NOTICE OF DENIAL

RE: Application Number 22-8057; 691 W. Canfield; West Canfield Historic District

CERTIFICATE OF APPROPRIATENESS

691 W Canfield SCOPE OF WORK

SOUTH SIDE

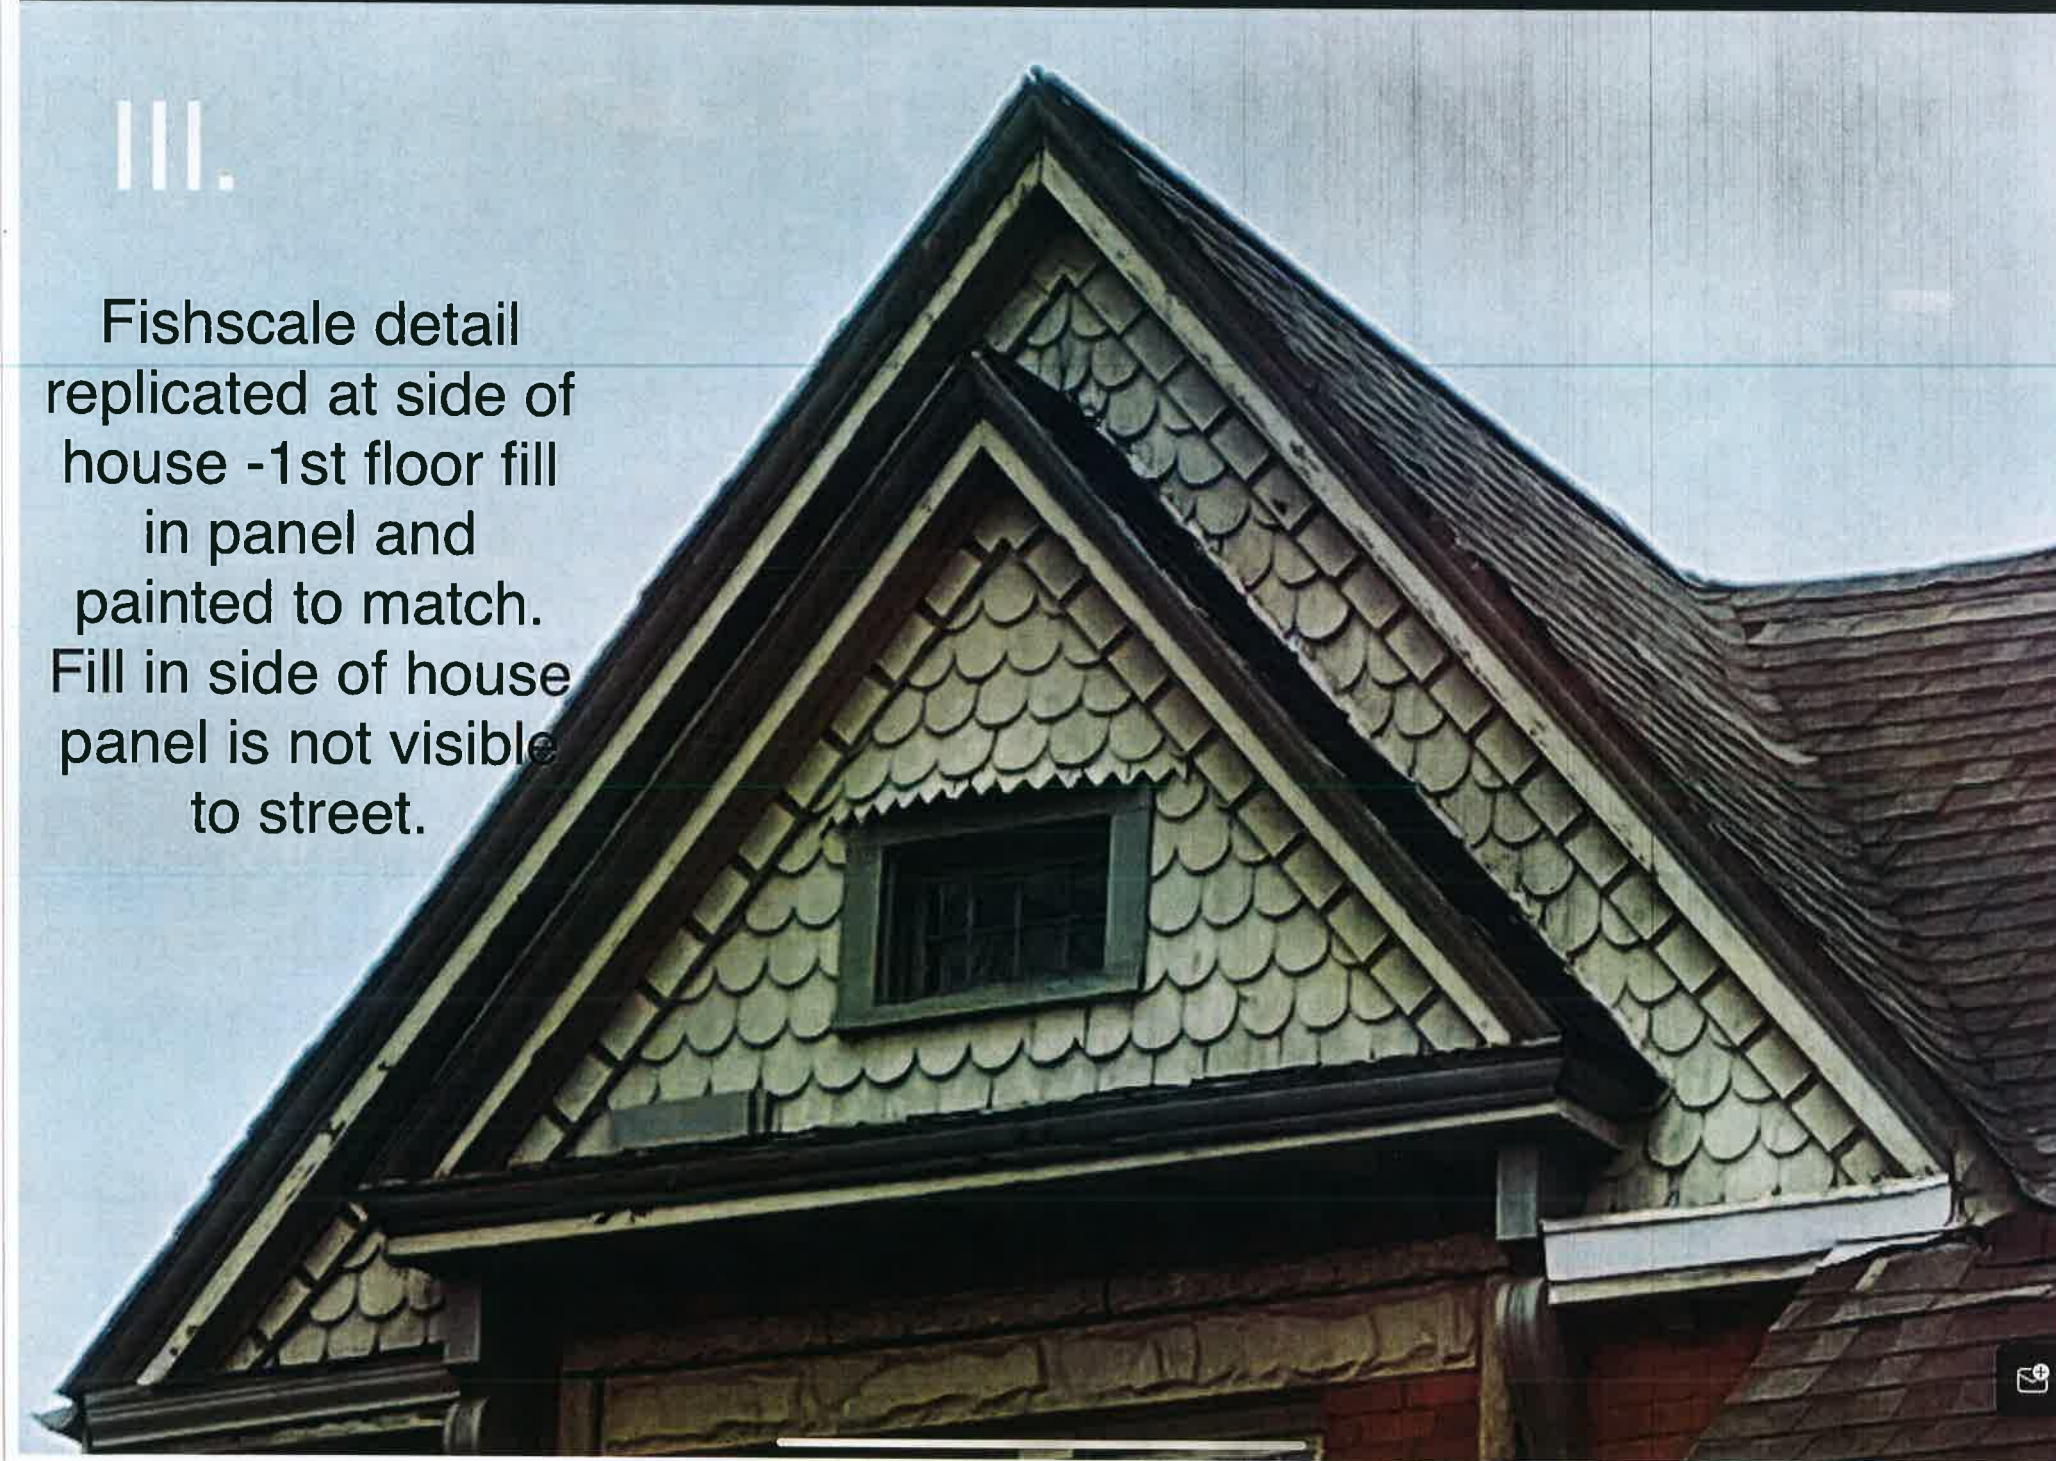
Rear of house 1st floor and basement, brick repair with old brick, brick in plywood on 1st floor, replace rotten door in basement.

Fishscale detail replicated at side of house - 1st floor fill in panel and painted to match. Fill in side of house panel is not visible to street.

1st floor, remove rotten doors, fill in with fish scale panel to match front of house and paint to match

EAST SIDE

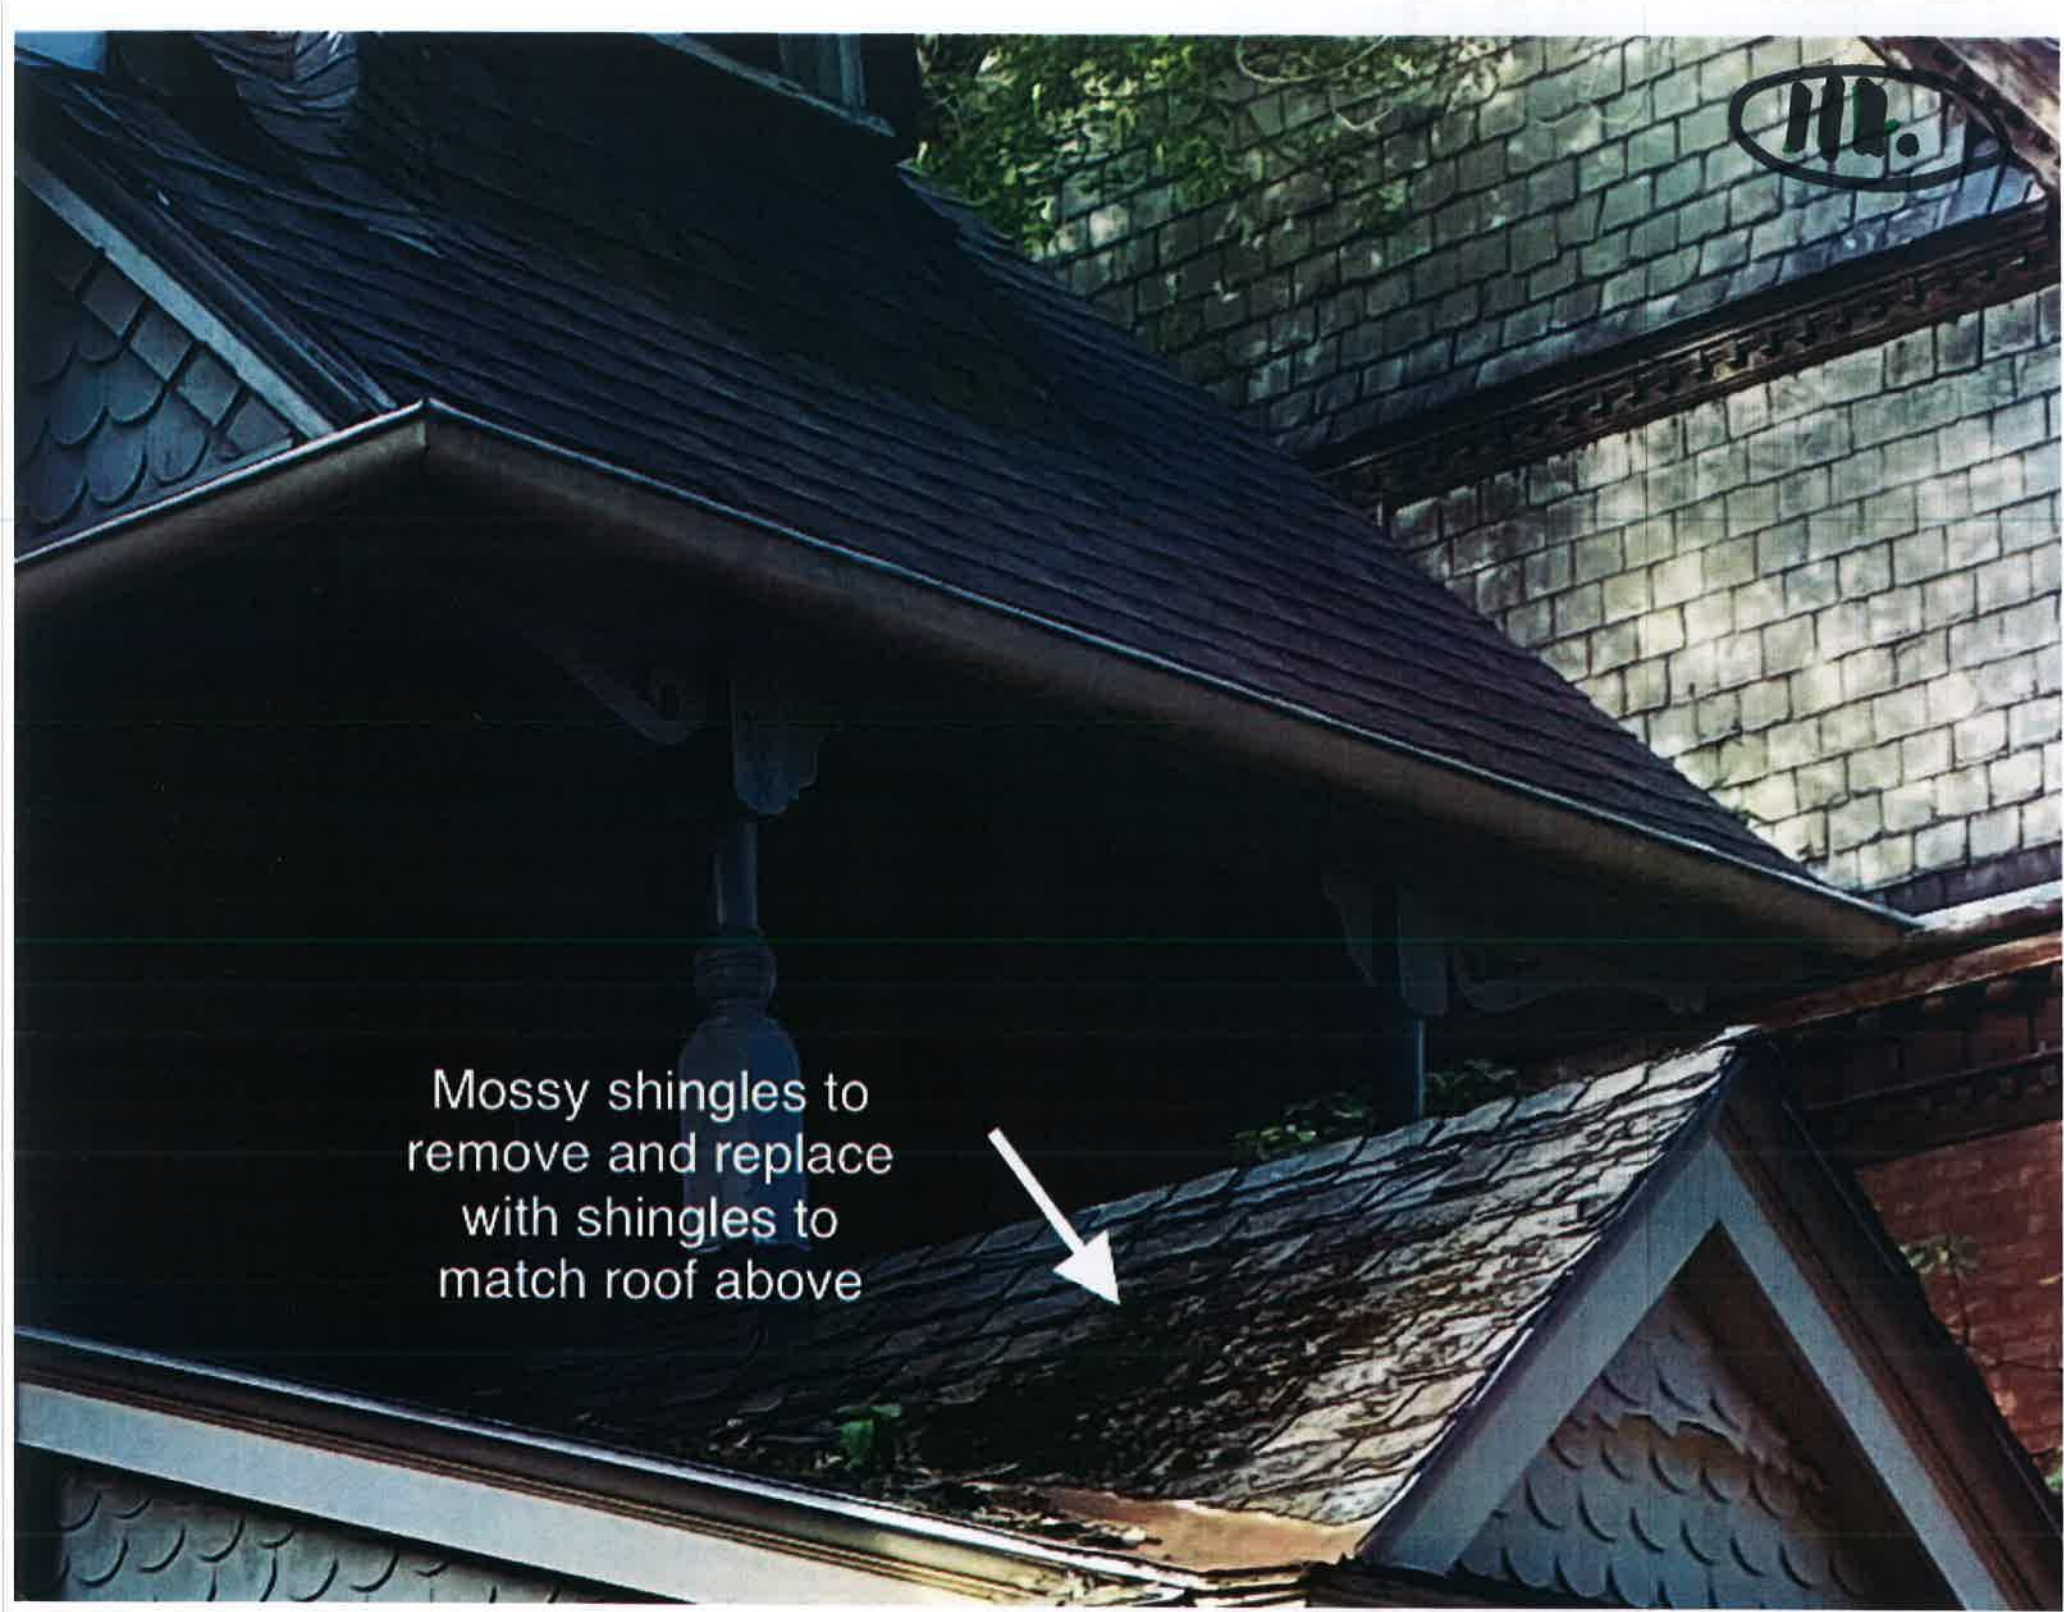
Basement level - not visible from street - Remove old metal pipe, repair brick where damaged or missing

NORTH SIDE

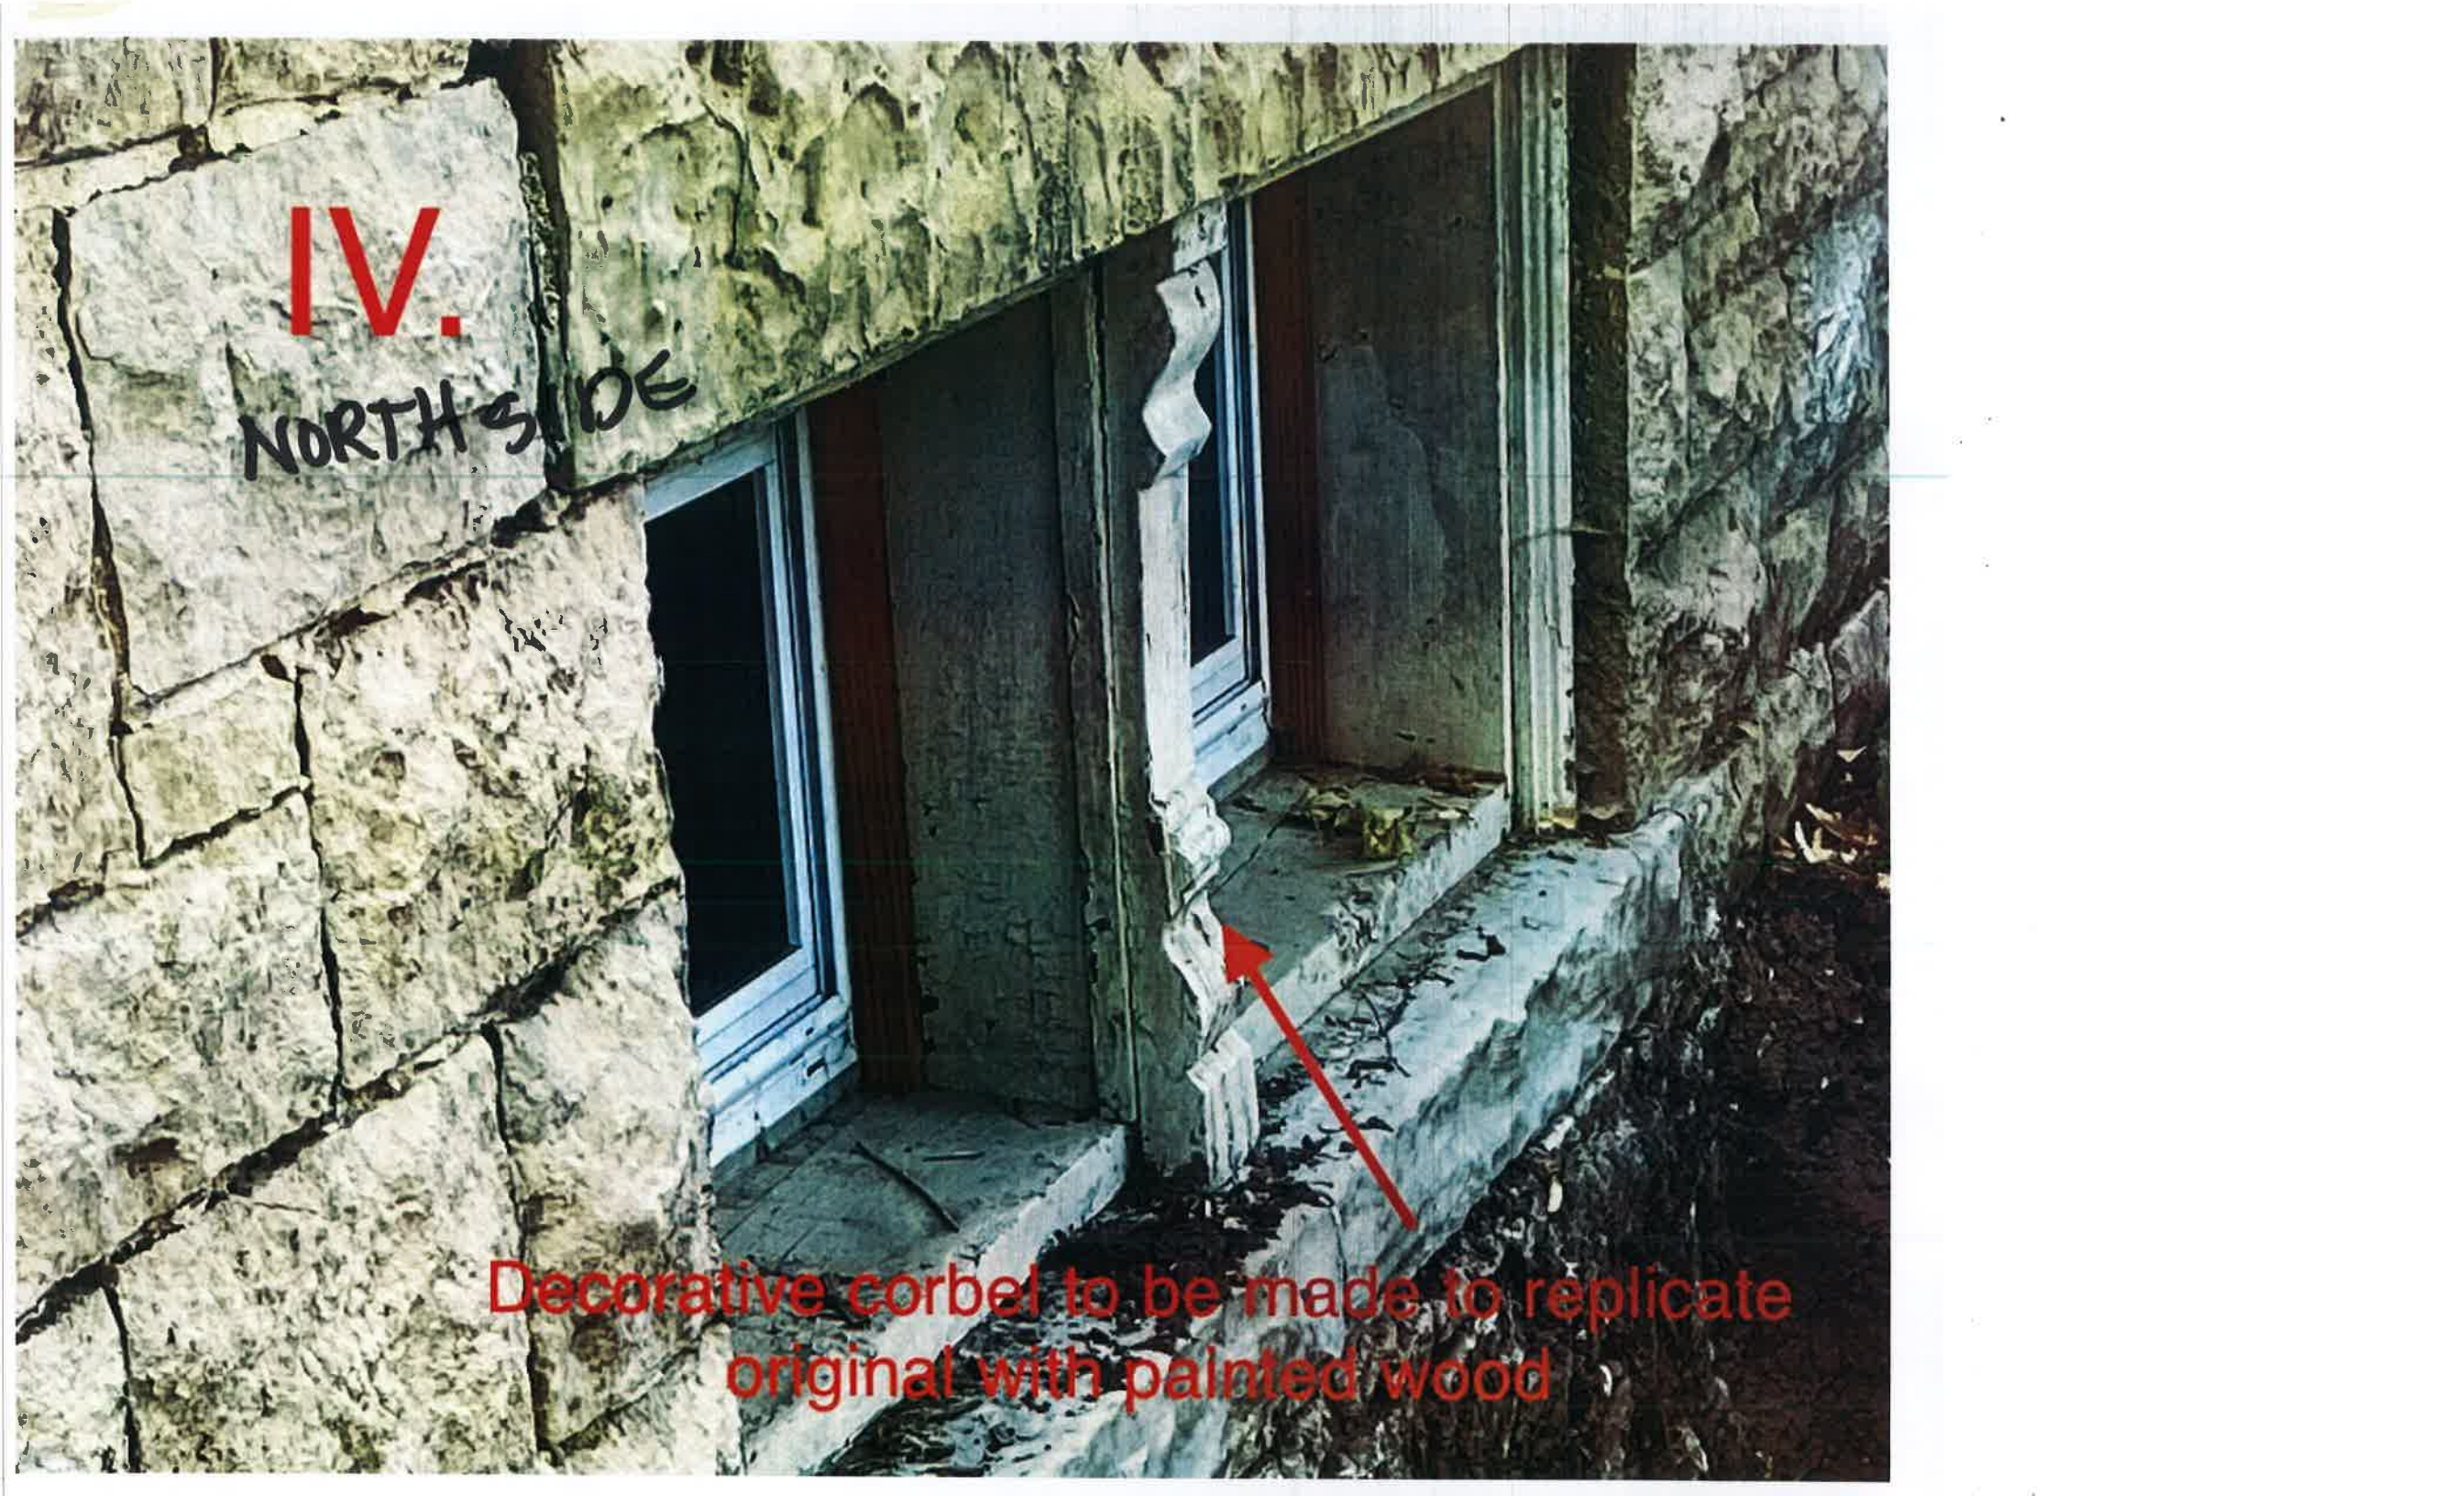
Basement level - Front vinyl slider windows to be replaced with code required egress windows. Middle corbel to be replicated in wood and installed in middle, painted to match existing.
